City of Turlock
Well 38 Arsenic Mitigation
And ICF Treatment

ADDENDUM NO. 1

**FOR: CITY OF TURLOCK
WELL 38 ARSENIC MITIGATION
AND ICF TREATMENT**

June 17, 2020

ITEM NO. 1:

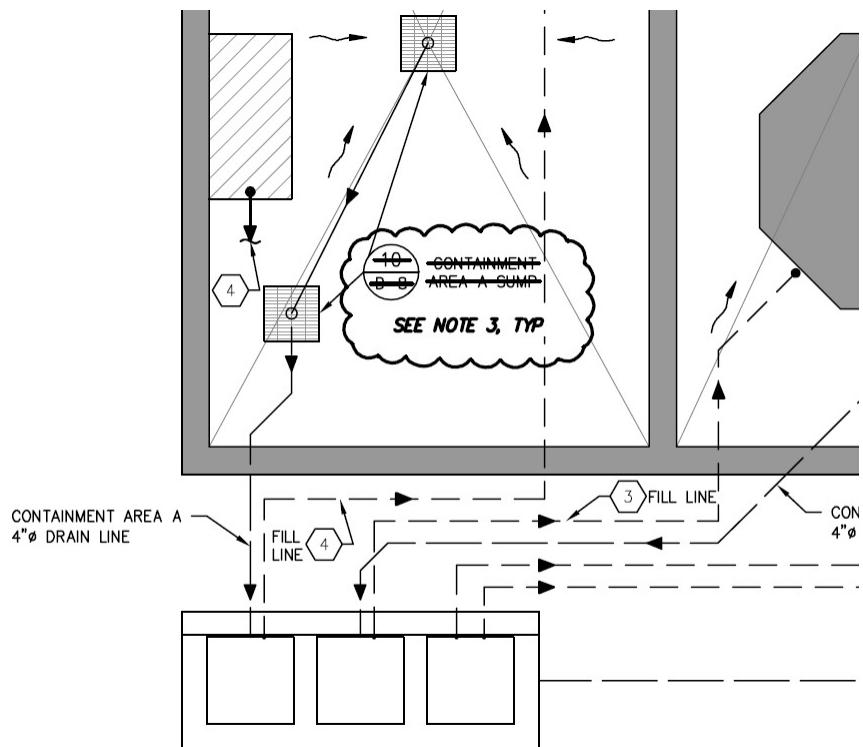
Plug Valves:

Type 1 – Eccentric Plug Valves 2-1/2 through 20 inches:

Eccentric plug valves shall be of the non-lubricated eccentric type with cast iron bodies, resilient faced plugs, or shall include replaceable, resilient seat in the body. Except as otherwise indicated, all valves for sizes 4-inch and larger shall have worm gear operators, nickel or stainless steel seats, and ANSI 125 psi flanged or grooved ends. Valves 2-1/2 inches and smaller shall have operating levers, nickel or stainless steel seats, and threaded ends with resilient facing suitable for the intended service. Submerged and buried valves shall be equipped with worm-gear operators, lubricated and sealed to prevent entry of dirt and water into the operator. Shaft bearings shall be stainless steel furnished with permanently-lubricated bearing surfaces. Operators shall clearly indicate valve position. Valves up to and including 20 inches in size shall have an unobstructed port area of not less than 80 percent of full pipe area, and not less than 70 percent for larger valves. Eccentric plug valves shall have a pressure rating of not less than 150 psi water, oil, or gas (WOG) service and bubble-tight shut-off. Valves shall be coated per Section 09 90 00 System 7 or with fusion bonded epoxy.

ITEM NO. 4:

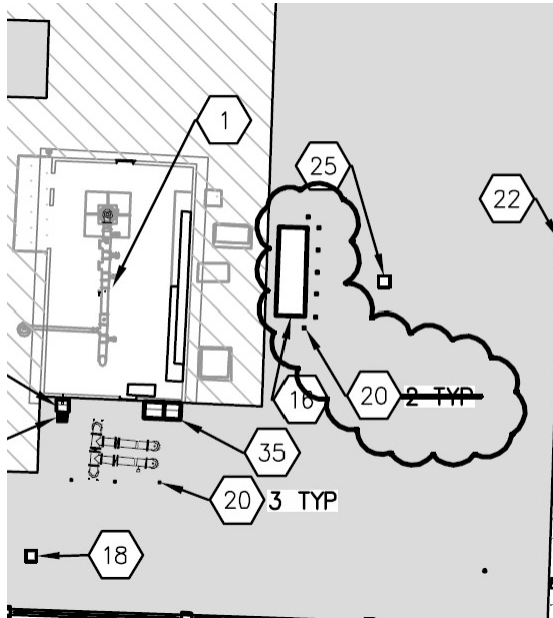
Add the following immediately after Part 3.4F

- G. Under Interior Slabs on Grade: Install 4 inches thick crushed aggregate base per Section 200-2.2, SSPWC or Class 2 CCS as capillary break. Over aggregate base place 15-mil vapor barrier in largest practical sections. Seal all 6-inch lapped seams, penetrations and foundation perimeters using manufacturer-approved tape only and install per manufacturer instructions. Install pipe boots at pipe penetrations. Install reinforcement and concrete as scheduled. Install 1 1/2" of coarse, washed sand over Vapor Barrier.**
- 1. Installation of vapor barrier shall be in accordance with ASTM E 1643 and manufacturer's instructions.**
 - 2. Tapes, mastics, sealants, and other products used with vapor barrier shall be from same manufacturer as, and certified compatible with, vapor barrier.**

Sheet P30-02

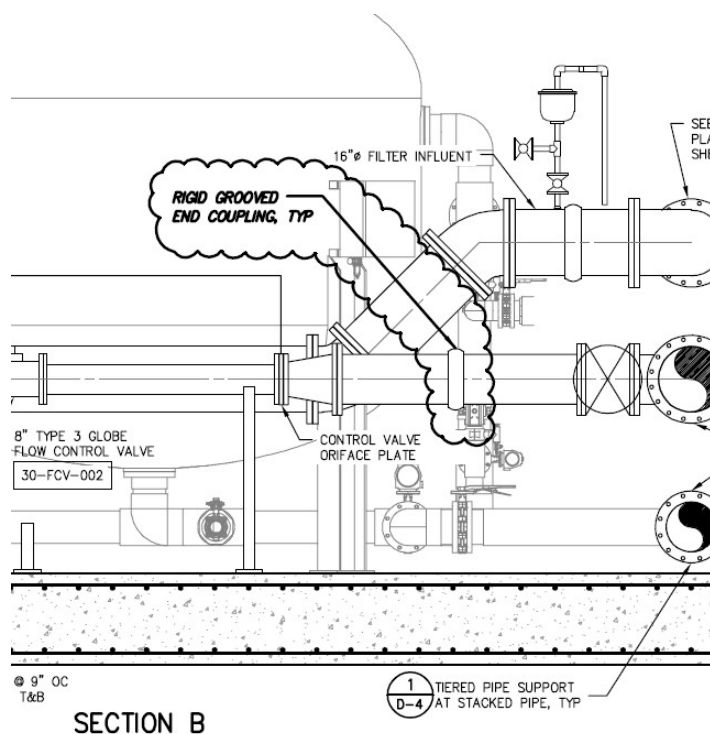
Question No. 31: Section C on Sheet P30-02 shows victaulic couplings installed on the 16"/12" filter influent line. These couplings are not shown on P30-01. Please clarify.

Add callout for Rigid Grooved Coupling as follows:

Answer No. 31: Rigid Grooved End Couplings Shall Be Provided as Shown in P30-02. See Revised Item No 6 Provided in this Addendum
